Re: Onondaga Lake Capping, Dredging, Habitat and Profundal Zone (SMU 8) Final Design, Modified Protective Cap RA-D2 Design Revision, Dated May 2016

**ONONDAGA LAKE CAPPING, DREDGING,
HABITAT AND PROFUNDAL ZONE (SMU 8)
FINAL DESIGN**

**MODIFIED PROTECTIVE CAP RA-D-2
DESIGN REVISION**

SUMMARY OF DESIGN REVISION

Figure 8. Calculated factors of safety and critical slip surfaces for Cross Section 3.

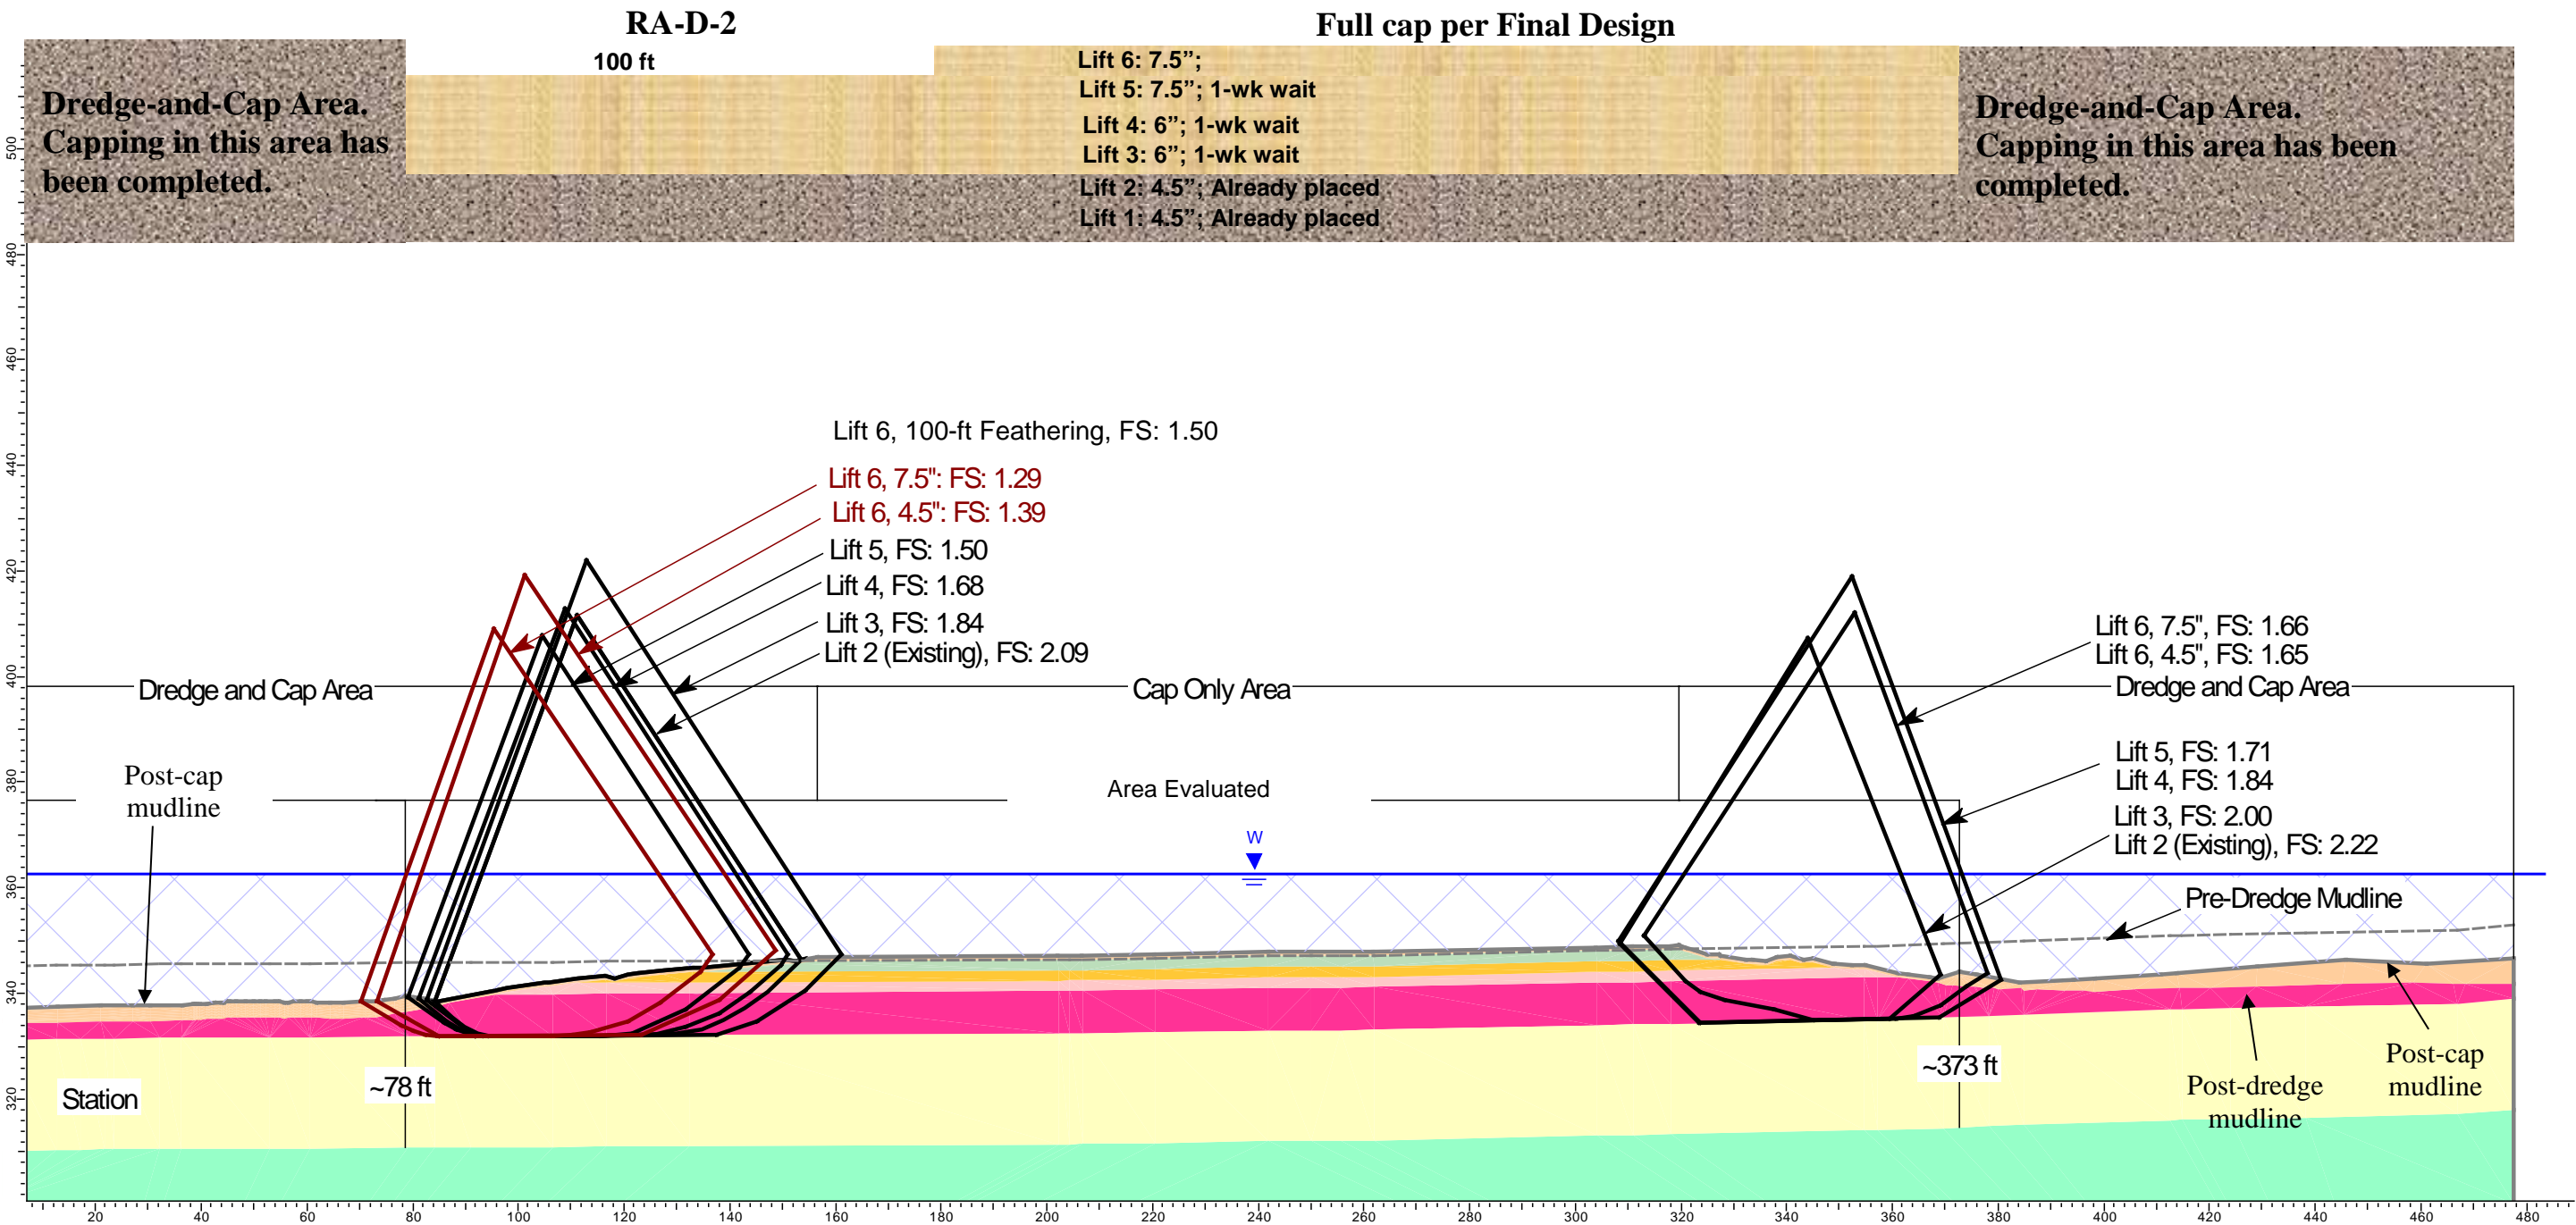
For Cross Section 3, the calculated slip surfaces on the western side of the cap-only area of RA-D-2 (i.e., left end of Cross Section 3) are shown in Figure 8 and the minimum calculated FS are listed in the table below.

Similar to the results for Cross Section 1, the calculated slip surfaces on the eastern side of the cross section generally resulted in higher calculated FS compared to the western side of the cross section, as presented in Figure 8.

Based on the results shown above, a full cap thickness per Final Design with a total of six lifts of cap (existing 2 lifts of 4.5 in. + additional 2 lifts of 6 in. + 2 lifts of 7.5 in.) with one-week wait time between lifts is recommended in a portion of the area yet to be capped, while a total of five lifts of cap (existing 2 lifts of 4.5 in. + additional 2 lifts of 6 in. + 1 lift of 7.5 in.) with one-week wait time between lifts is recommended in RA-D-2. The calculated slip surfaces for the last four lifts of cap (i.e., Lifts 3 to 6) during cap placement are deep, through the weak layer

Figure 9. Recommended cap placement in modified protective cap area RA-D-2.

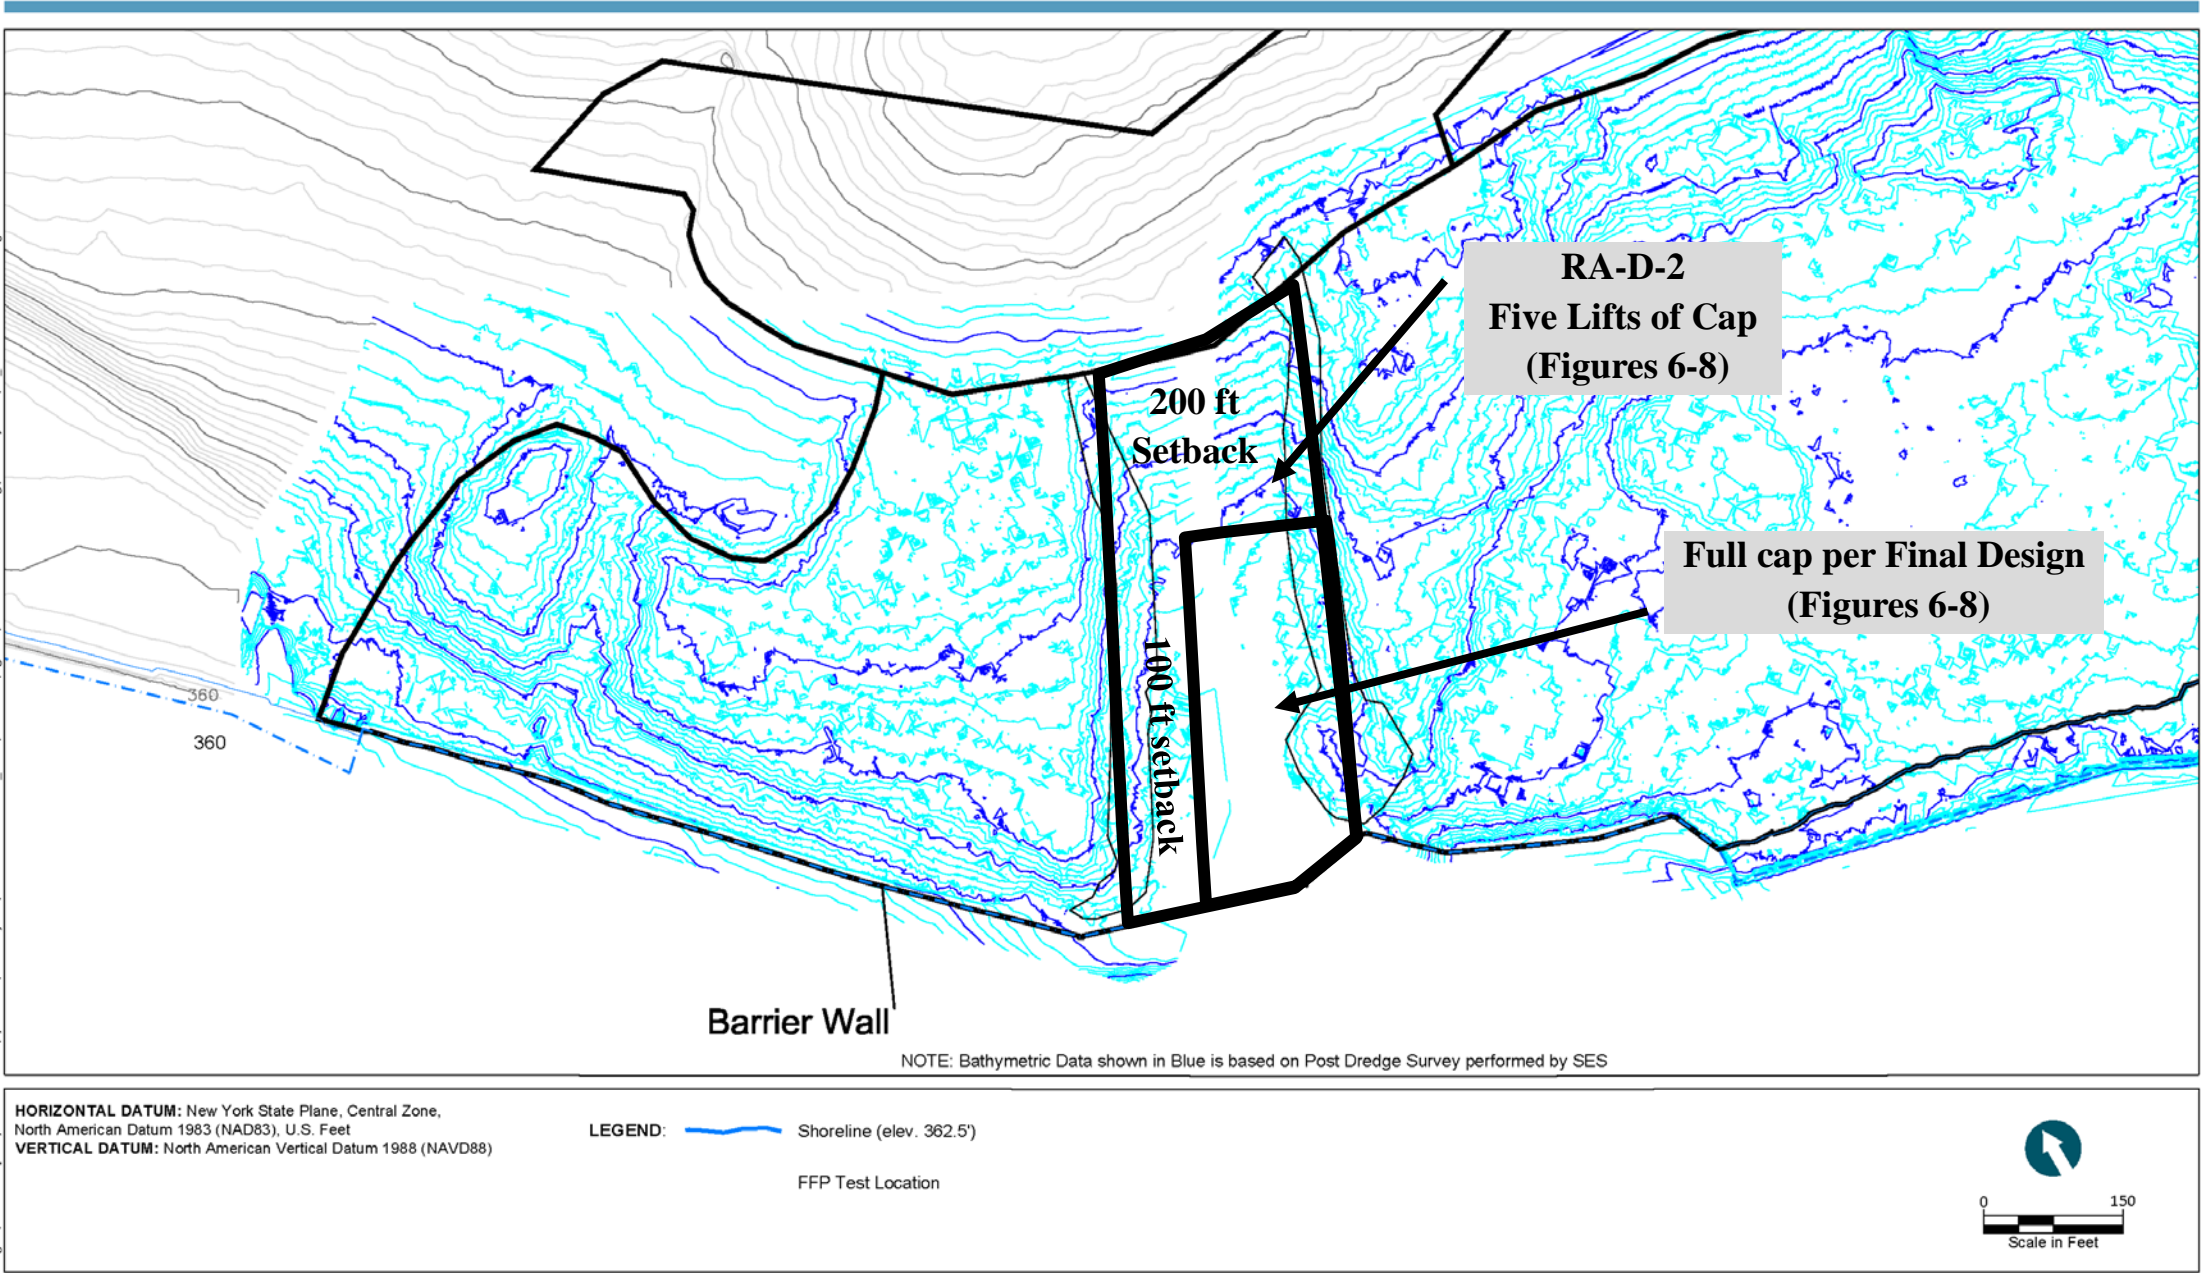
Figure 9 shows the recommendation for cap placement in the modified protective cap area of RA-D-2. The results of the slope stability analyses for the placement of multiple lifts of cap with one-week wait periods between lifts show that, in general:

- a full cap thickness per Final Design with a total of six lifts of cap (existing 2 lifts with average 4.5-in. per lift of siderite + additional two lift with average 6 in. per lift of GAC + two lifts with average 7.5 in. of sand habitat layer) with one-week wait time between lifts and the extensions into SMU-8 are recommended in a portion of the area yet to be capped.
- a total of five lifts of cap (existing 2 lifts with average 4.5-in. per lift of siderite + additional one lift with 6 in. of GAC + one lift with 6 in. and one lift with 7.5 in. of habitat layer) with one-week wait time between lifts and the extensions into SMU-8 are recommended in RA-D-2.
